# Addendum No. 1

**Project:** Fort Wayne International Airport  
Construct Taxiway G Extension & Demolish Taxiway C2  
AIP No. 3-18-0022-71

**Date:** June 14, 2024

Drawing No.: **X1.1.7**

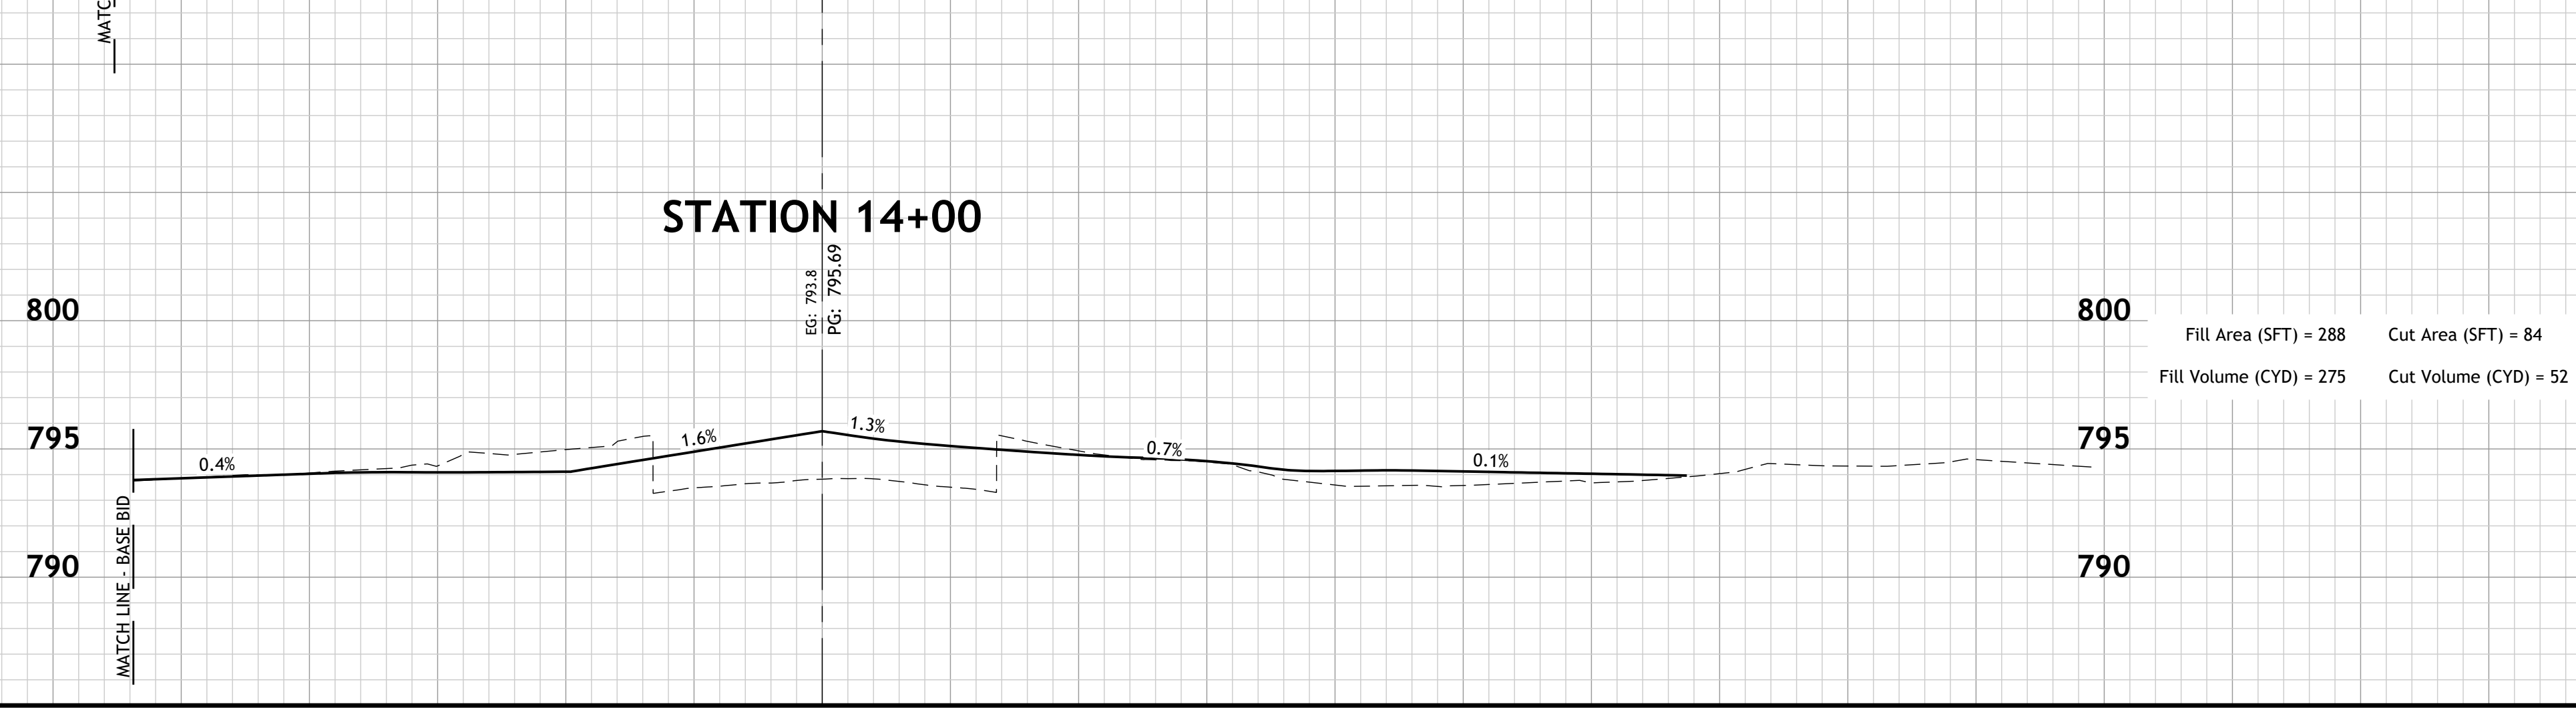
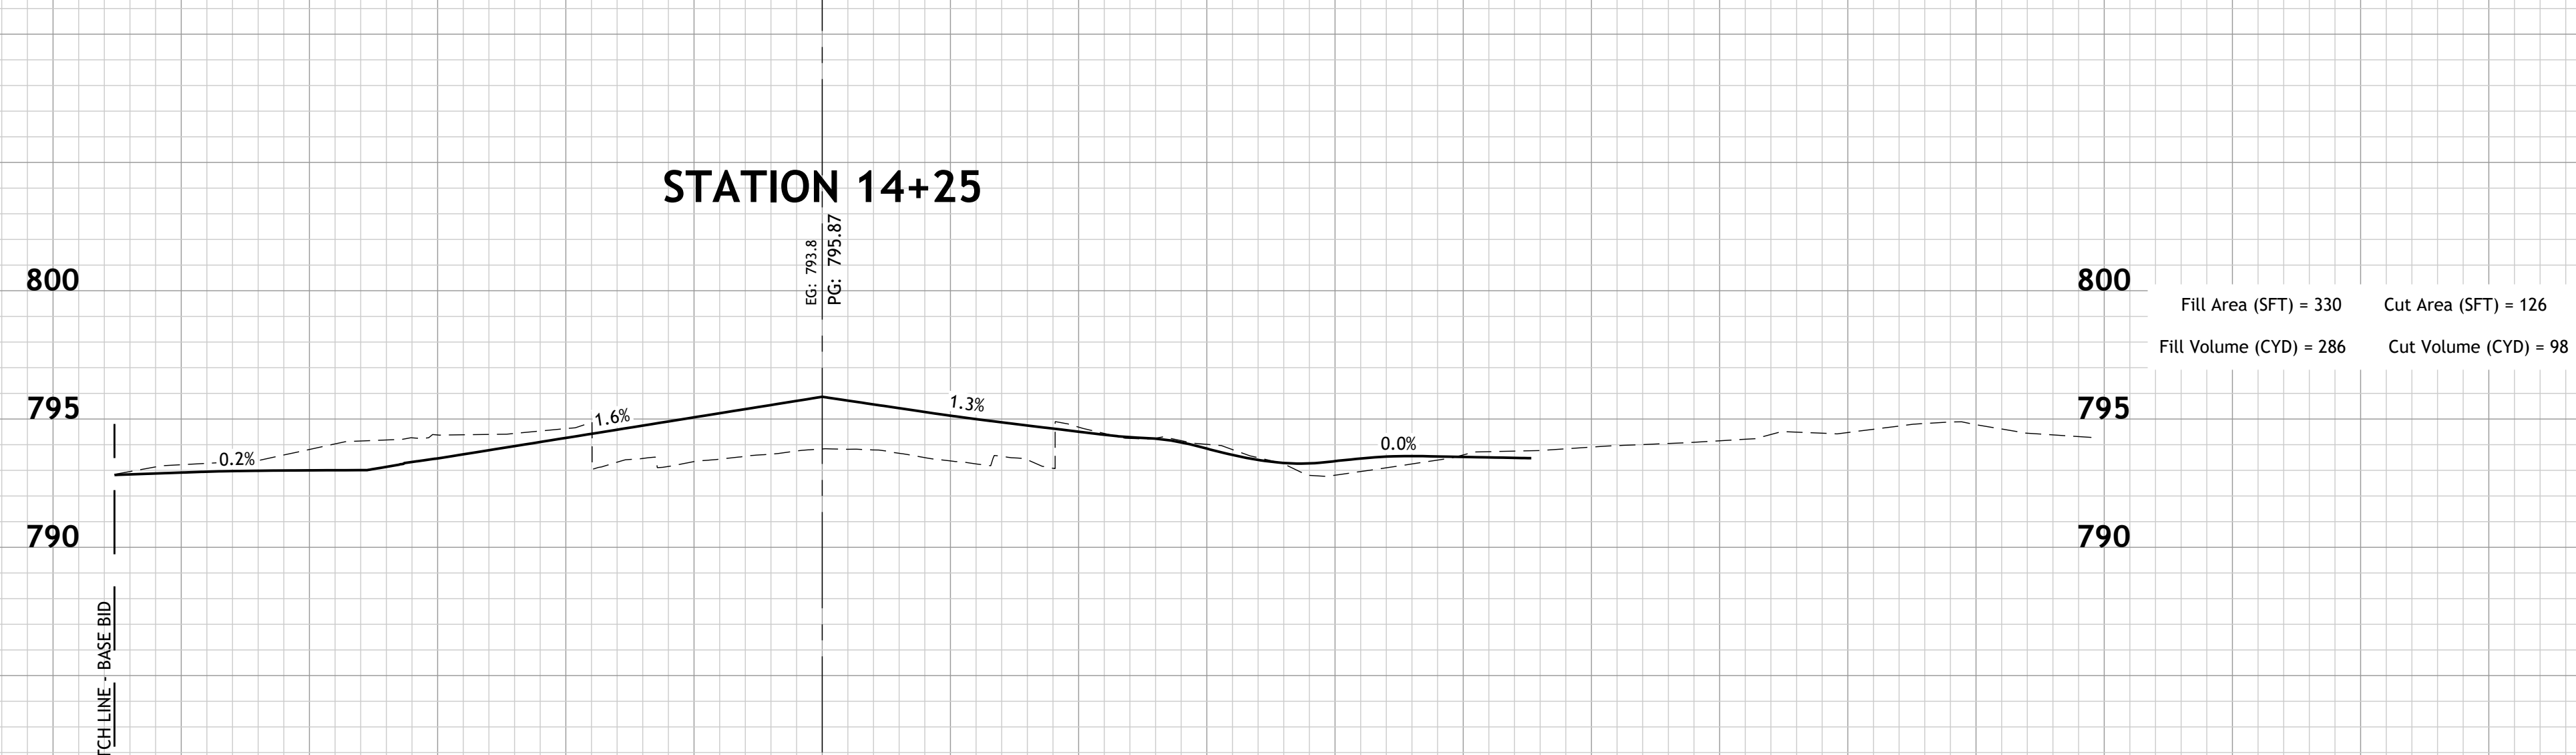
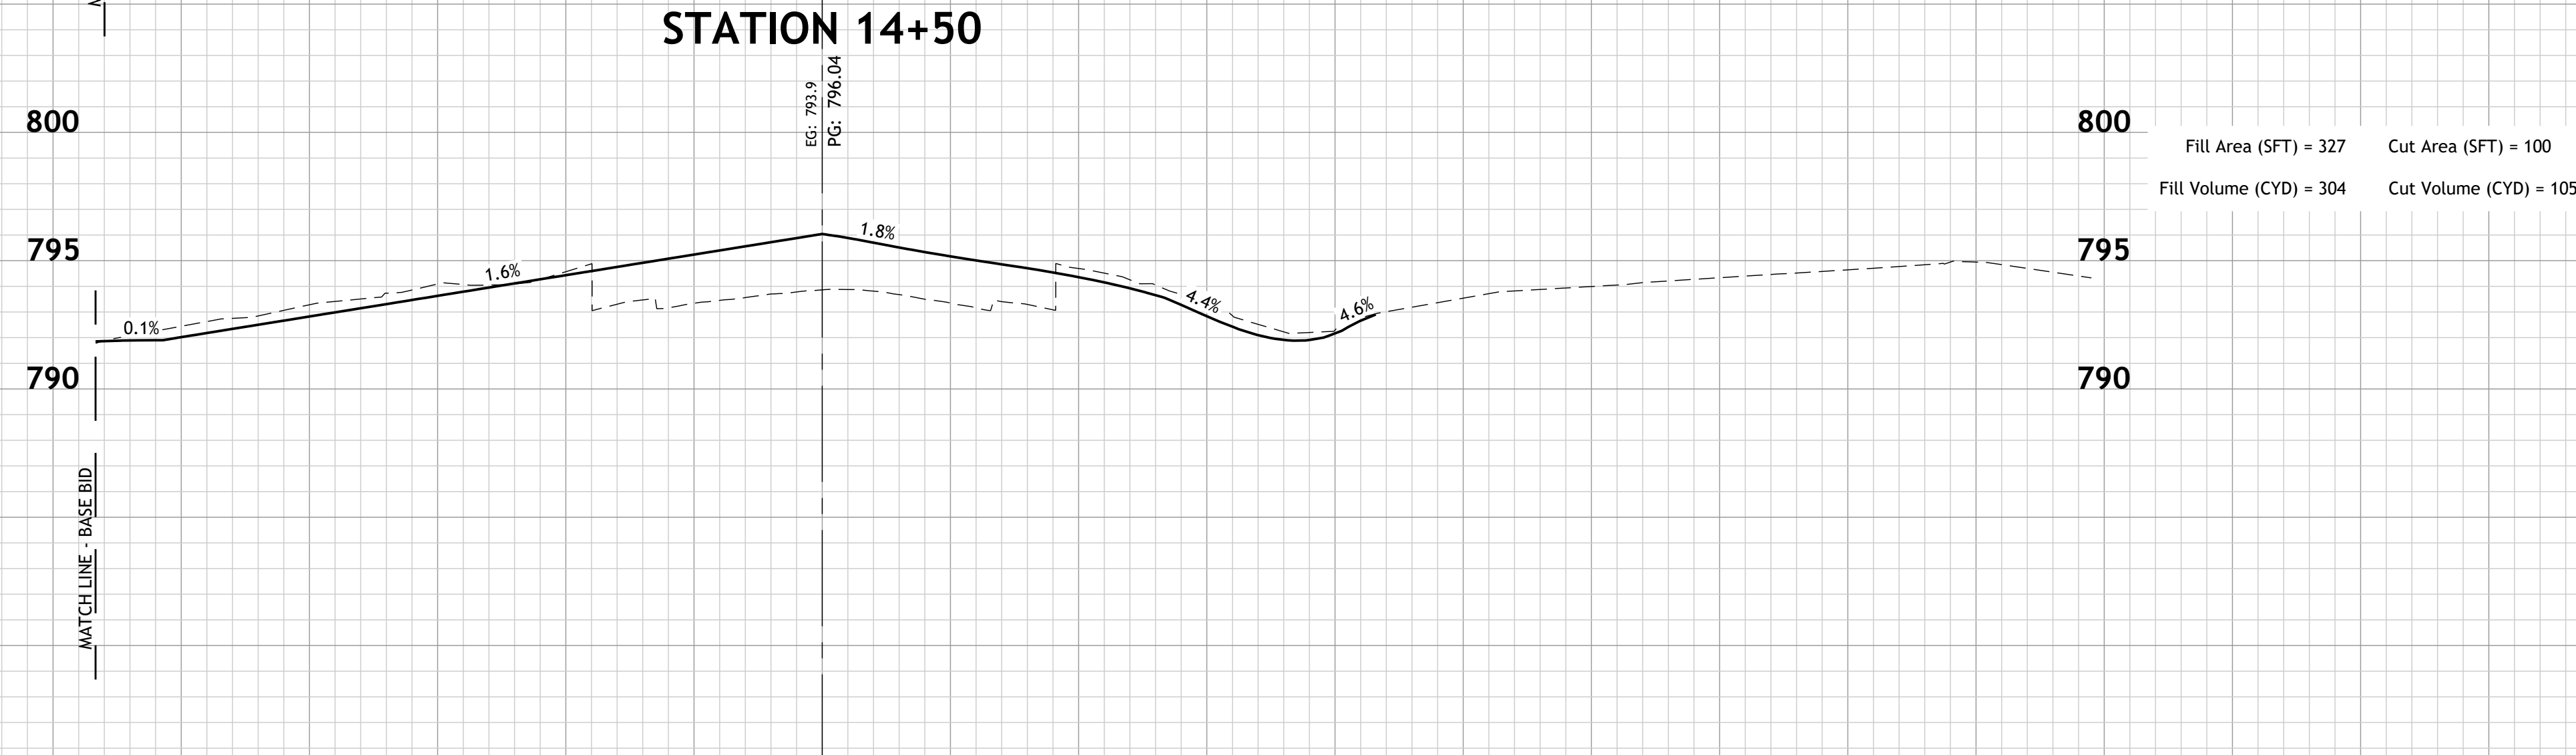
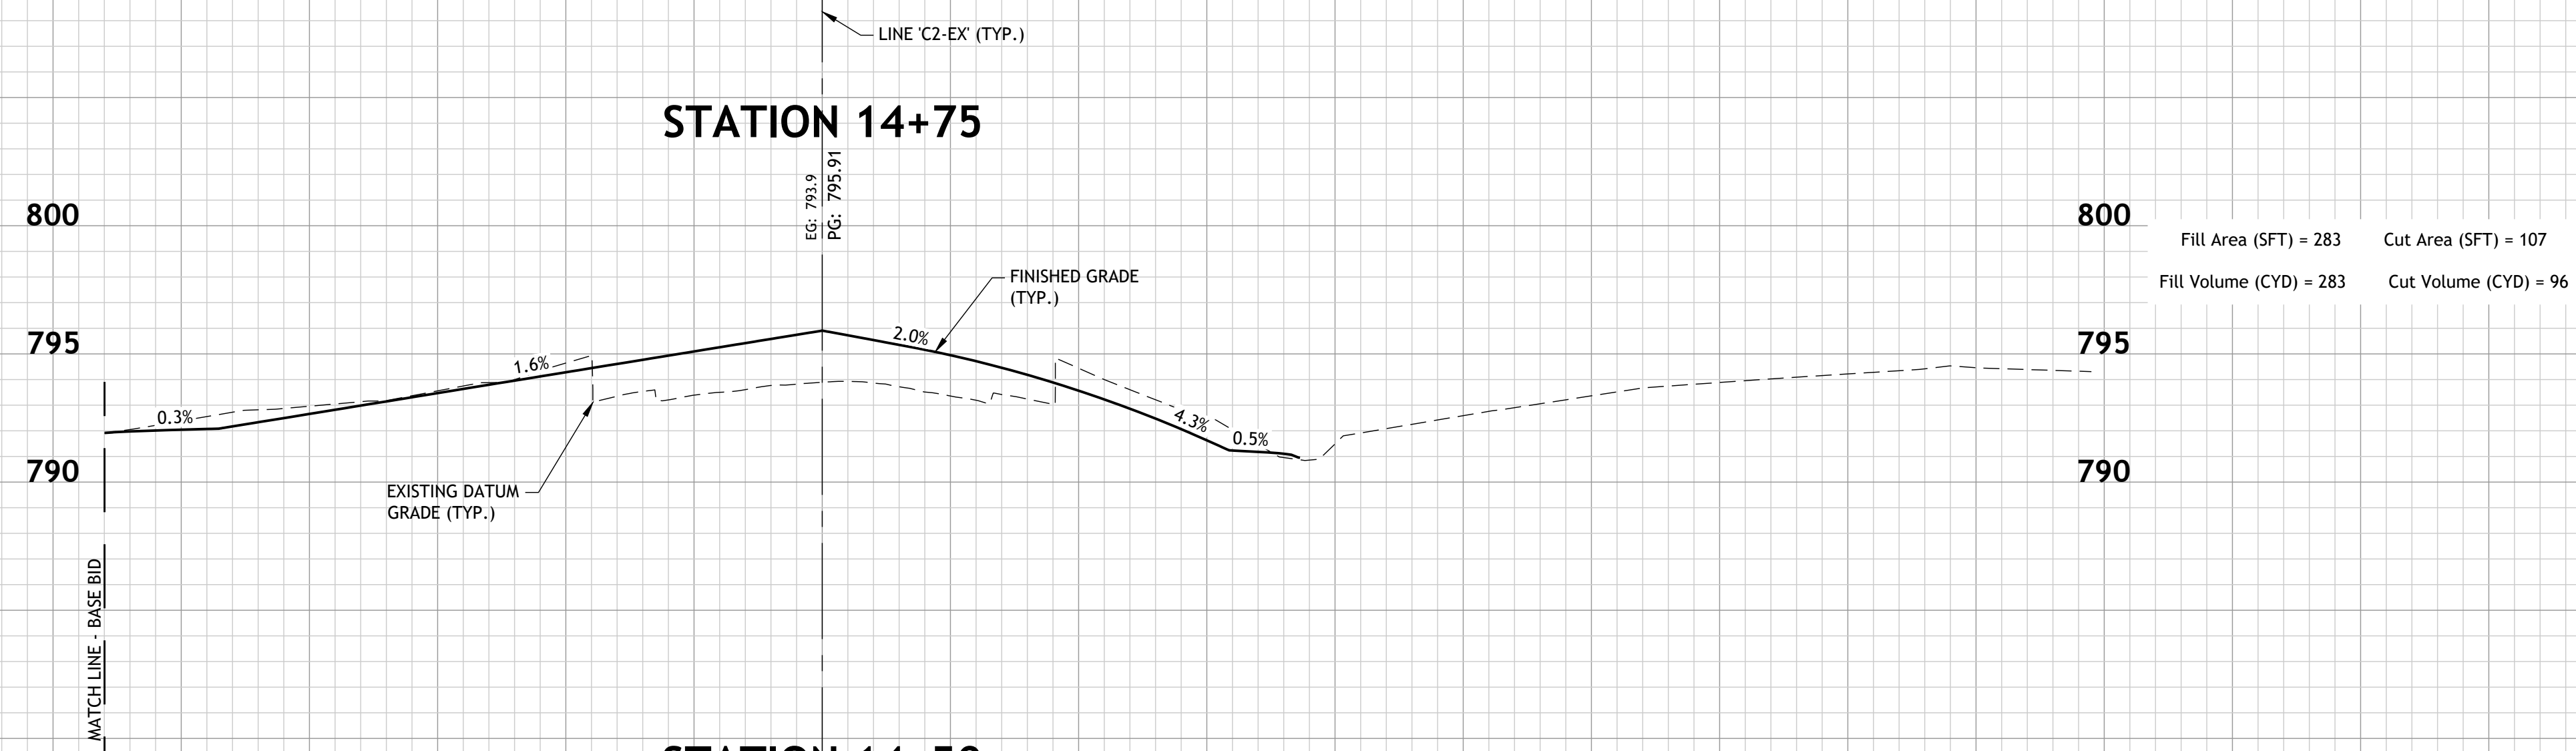
Reissued: Sheet reissued to show updated finished grade surface.
